**From:** Rhgilkeson@aol.com  
**Sent:** Friday, September 04, 2009 7:06 AM  
**To:** Kieling, John, NMENV  
**Cc:** Rhgilkeson@aol.com; ABERLYLAW@SWCP.COM; acree.steven@epa.gov; dave@radfreenm.org; jarends@nuclearactive.org; jd@campy.com; mayer.richard@epa.gov; mariann2@windstream.net; msantistevan@doeal.gov; serit@cybermesa.com; wilkin.rick@epa.gov  
**Subject:** Submittal of EPA Kerr Lab Reports to the NMED Public Comment Record  
**Attachments:** Kerr Lab Memo Feb 16, 2006.pdf; Kerr Lab Memo March 30, 2009,.pdf; Kerr Lab Memo, Feb 10, 2006.pdf

This e-mail brings to the attention of the New Mexico Environment Department (NMED) the three reports by the Environmental Protection Agency (EPA) Kerr Research Laboratory (EPA Kerr Lab) that describe the deficiencies in the various versions of two LANL reports that were approved by the New Mexico Environment Department.

*LANL Well Screen Analysis Report - Revision 2 (LA-UR-07-2852 May 2007)*

*LANL Groundwater Background Investigation Report - Revision 3 (LA-UR-07-2853 May 2007)*

Figure 3. Schematic of the pipe-based wire-wrap stainless steel well screen installed in many of the LANL characterization well R-22.

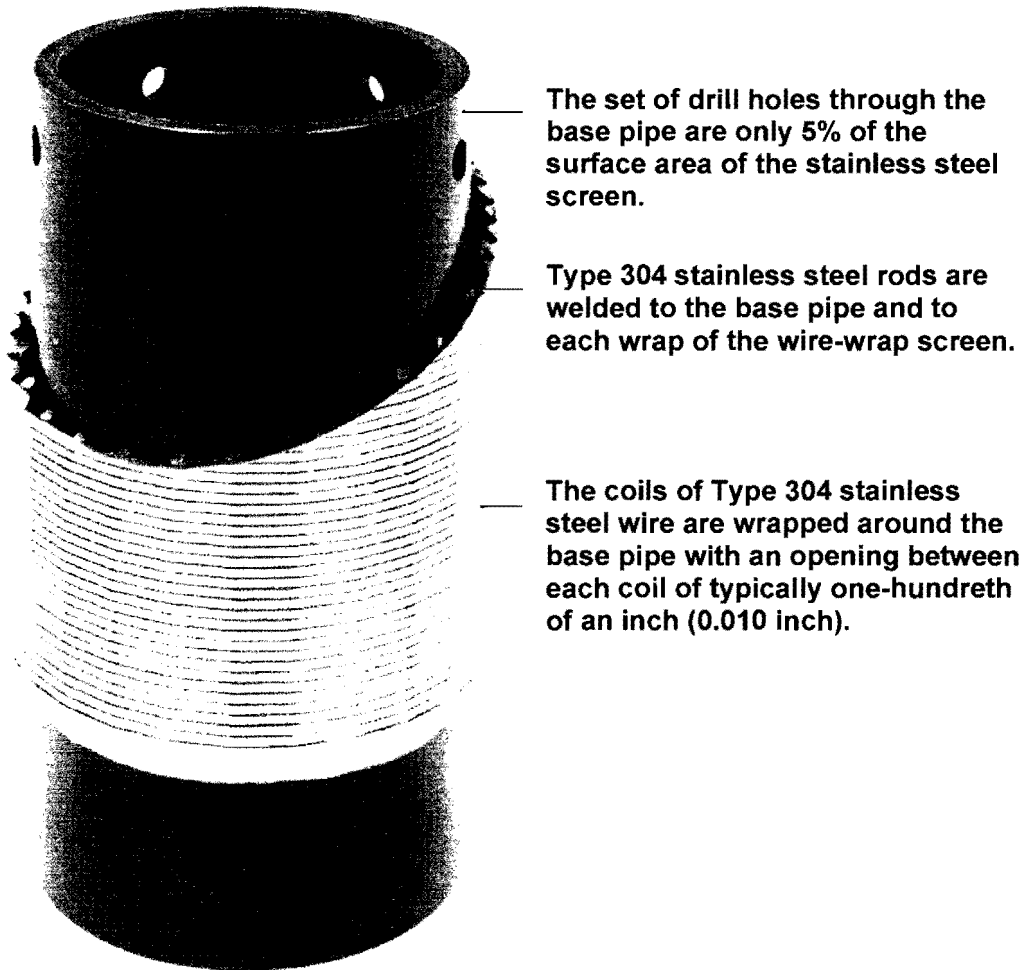
- The R-22 Plan does not recognize the LANL reports that show the well development performed in November of 2000 was not successful in removing the organic drilling additives or the bentonite clay grout from screen #3. The pipe-based design of the well screen is one factor that prevented the well development from being successful. The restrictive design of the pipe-based screen is displayed and described in Figure 3.
